ANSEMI ACRES

Improvement Plans

Anselmi Acres Subdivision
WEBER COUNTY, UTAH
Cover/Index Sheet

Control Box/ Combo Box
SCALE: NONE

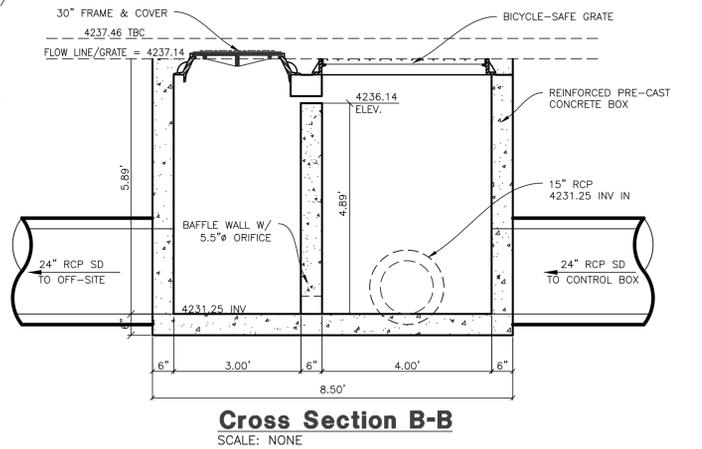
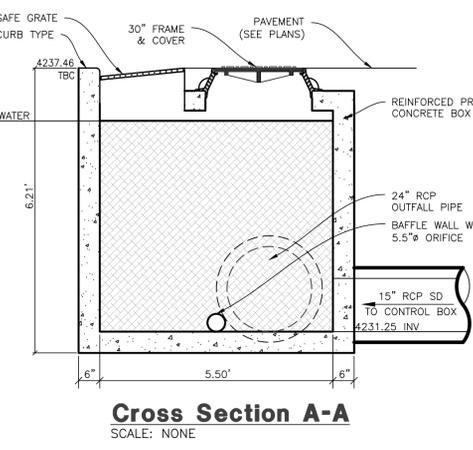
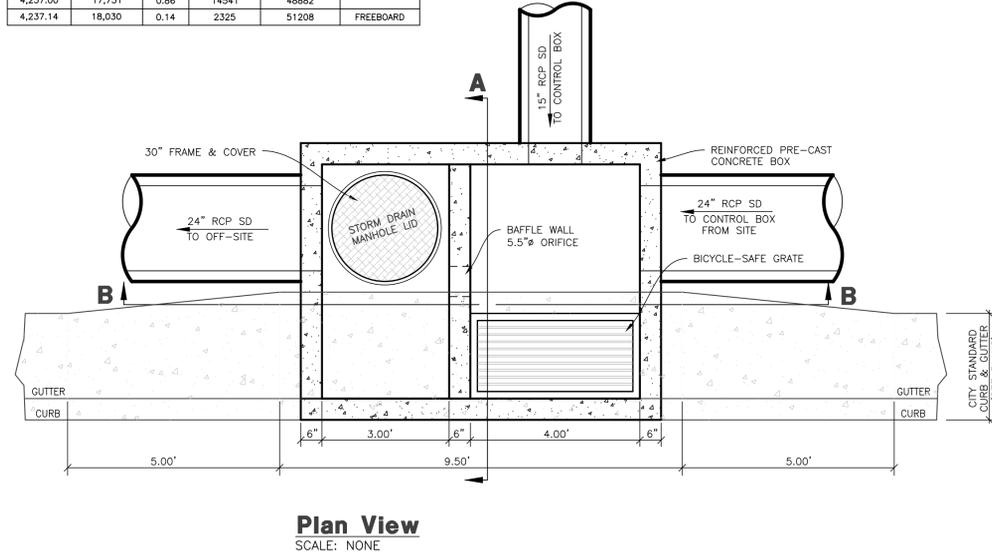
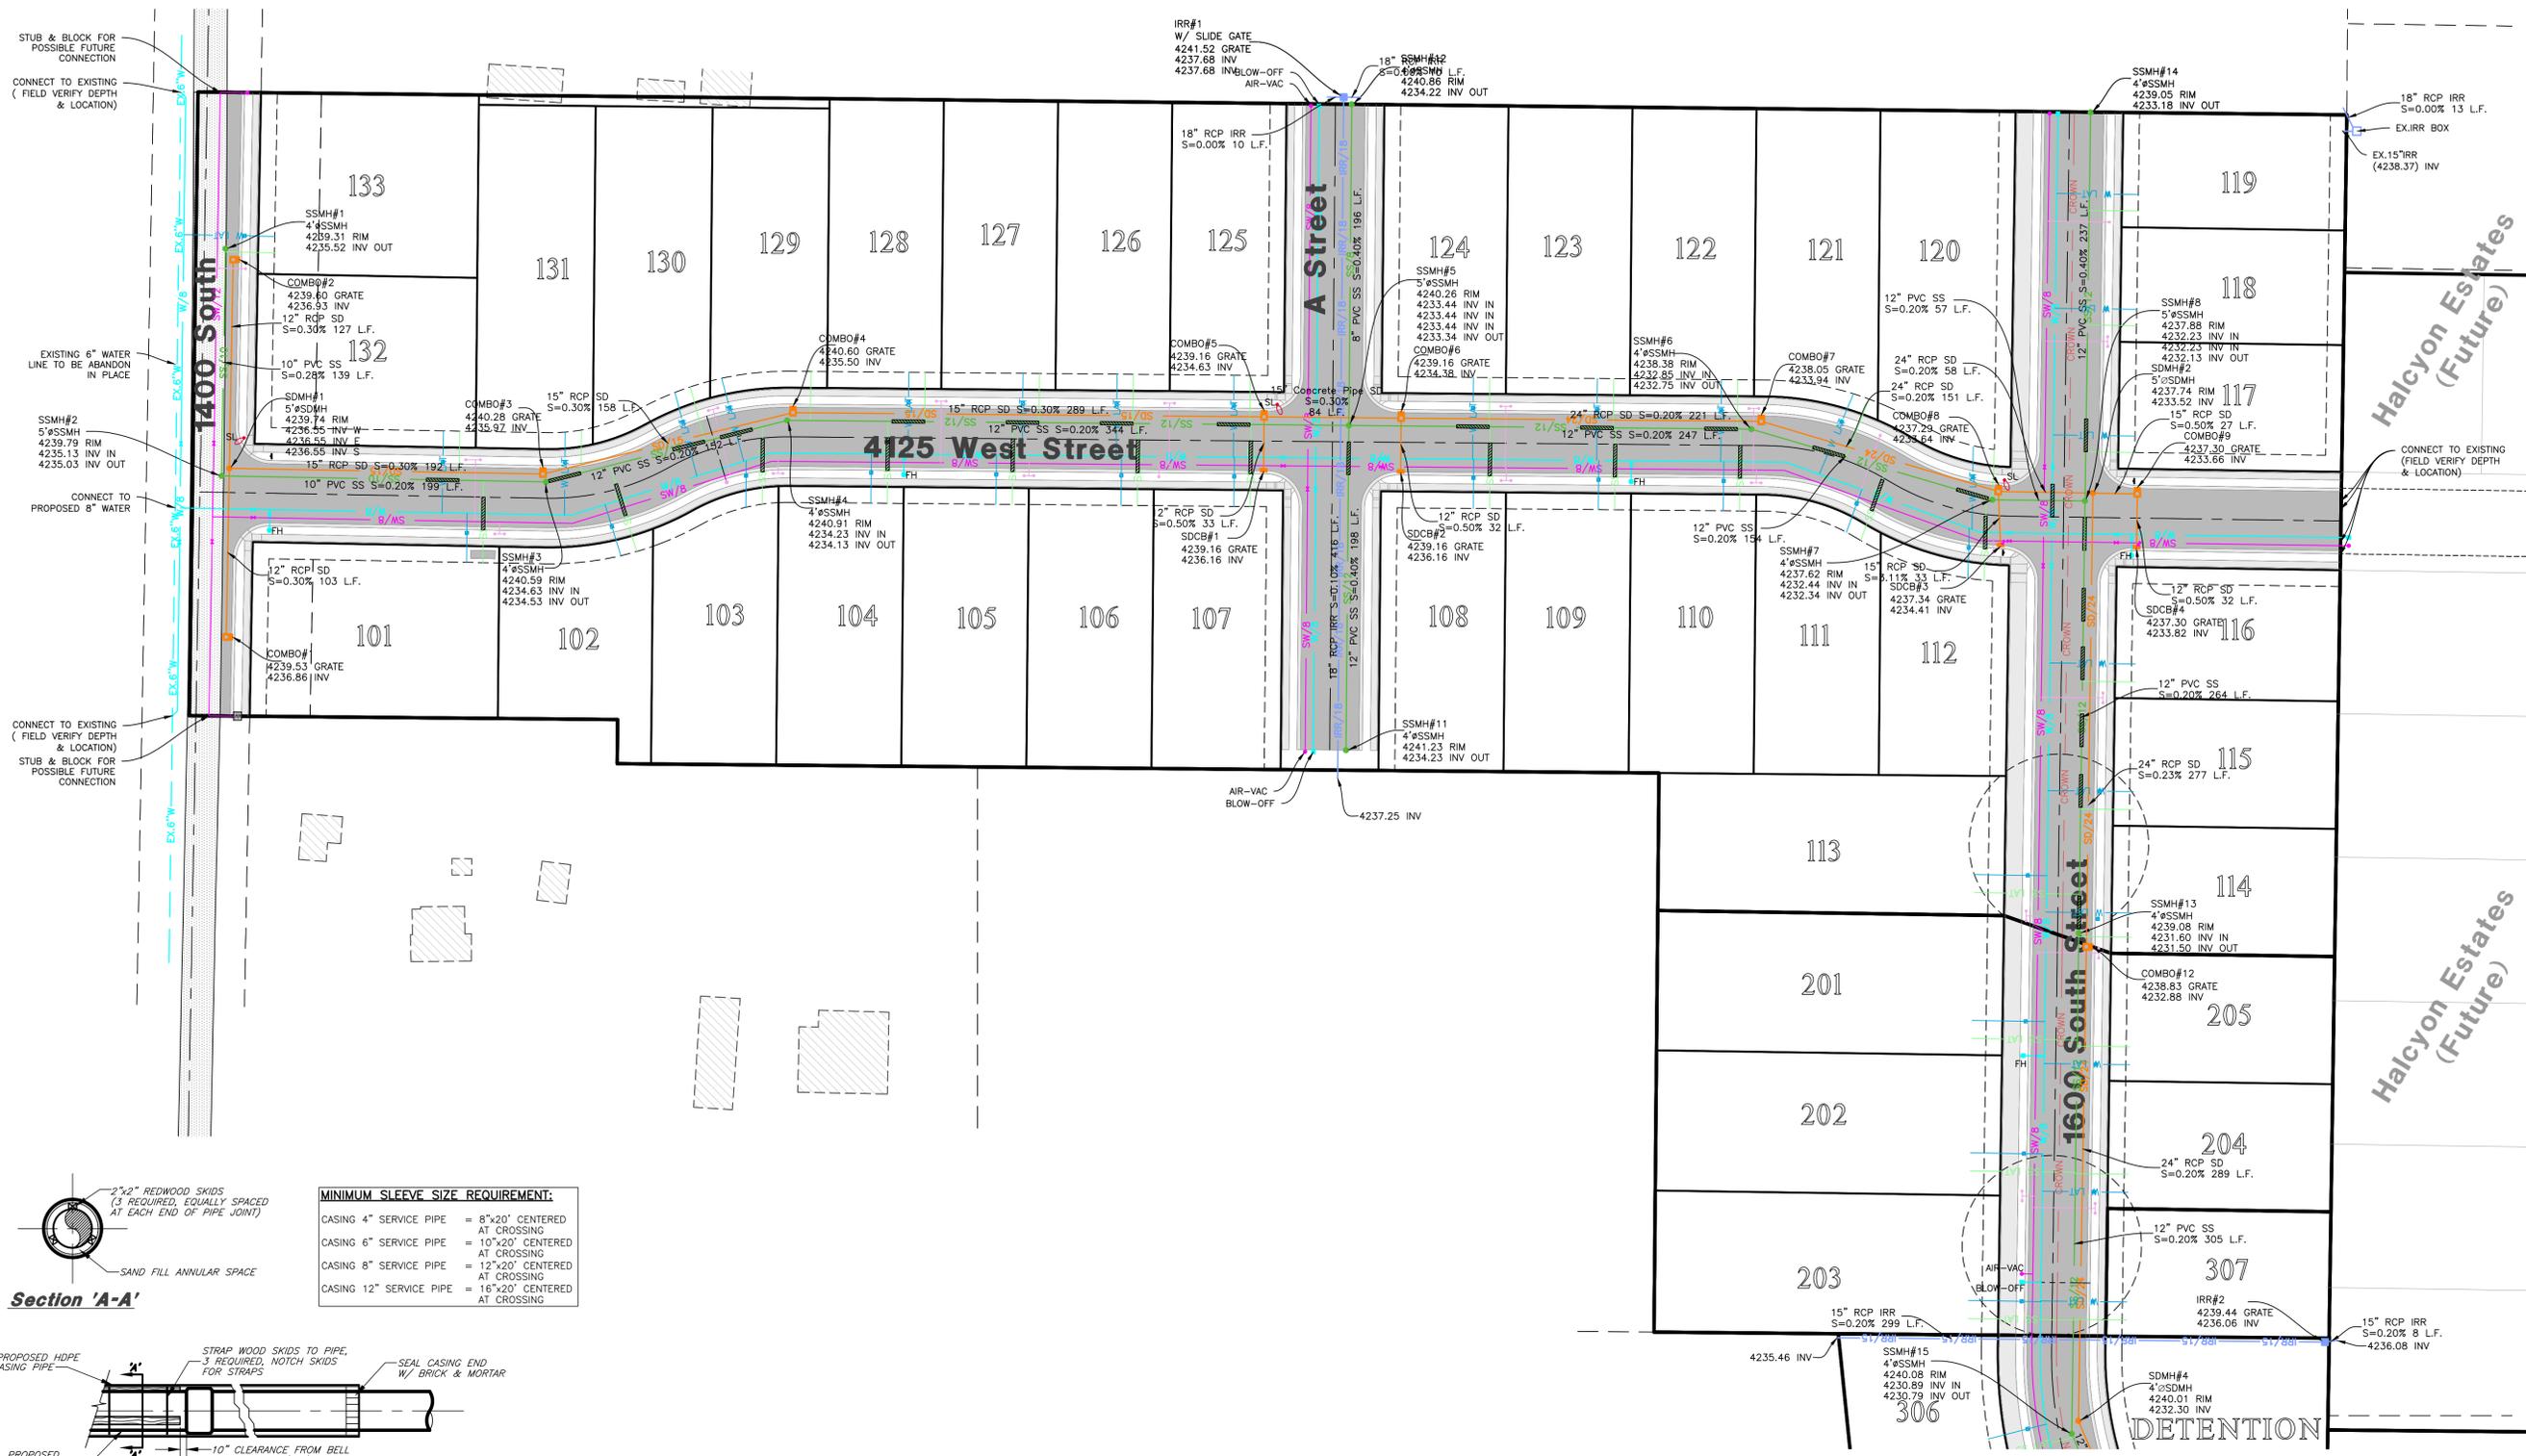
What material is the pond?

Add 1' Sump to Control Box

Phase 3 Utility Plan
 Scale: 1" = 50'

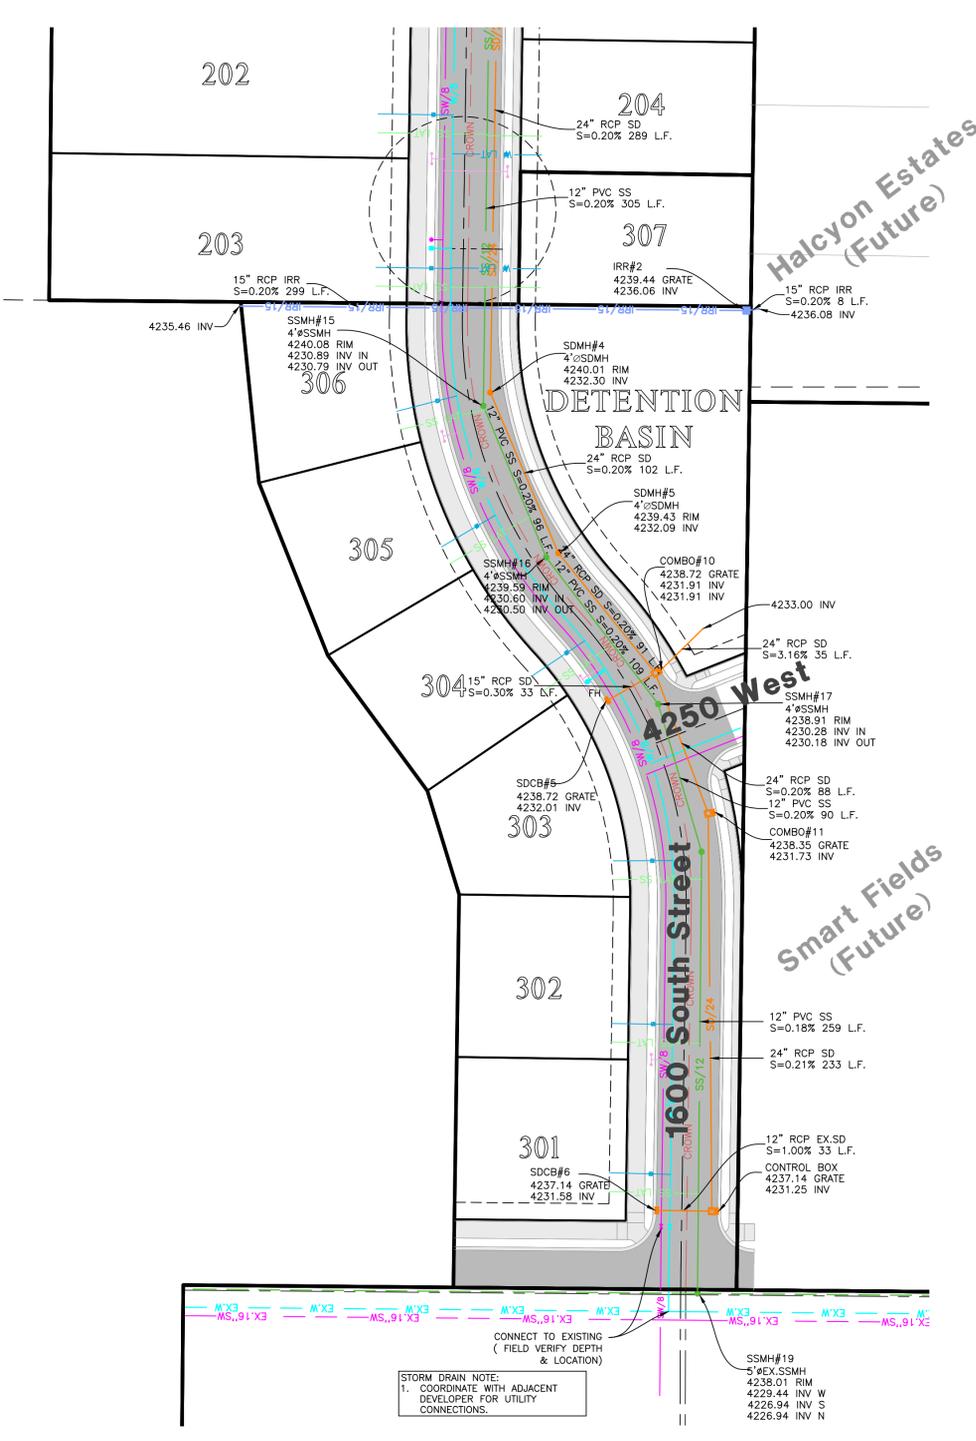
Other phases?
